Technical Construction Feasibility Review  
Final Report

**National Compact Stellarator  
Experiment (NCSX) Project at  
Princeton Plasma Physics  
Laboratory (PPPL)**

## **Response Summary**

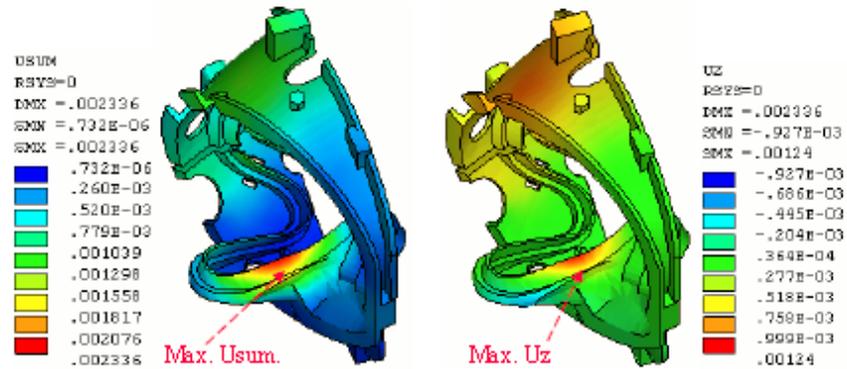
11. The committee expressed concern that the modular castings vary in thickness and weight, and this may affect the structural response. The project responded with an explanation that the electromagnetic deformations were predominantly caused by the flexibility of the machined parts, but the effect of non-uniform shell thickness should be addressed in the FEA benchmarks.

Fig. 1. Details of maximum displacement location. This is from an earlier model, and therefore the precise displacements are not comparable to the updated analysis run presented, but are illustrative of the localized displacement behavior. Most of the displacement is due to displacements in the septum of the T section rather than the wing itself.

Fig. 4. Full Period with PF coil shown as segments. Note lead details – routing of coolant lines, bus connections, etc. are underway and will be added as details are developed.

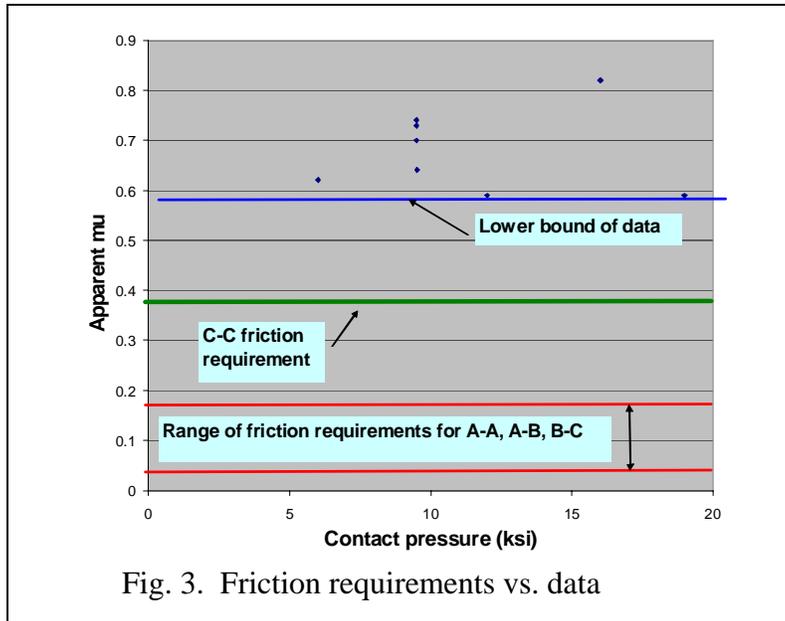
17. The committee suggests that power lead routing, coolant line routing, etc. be determined as soon as possible to avoid downstream interferences.

10	Suggest that power lead routing, coolant line routing, etc. be determined as soon as possible to avoid downstream interferences.	Agree – these activities are currently underway; ORNL and PPPL keep in close contact on these routing activities. A typical integrated model is shown in Fig. 4.
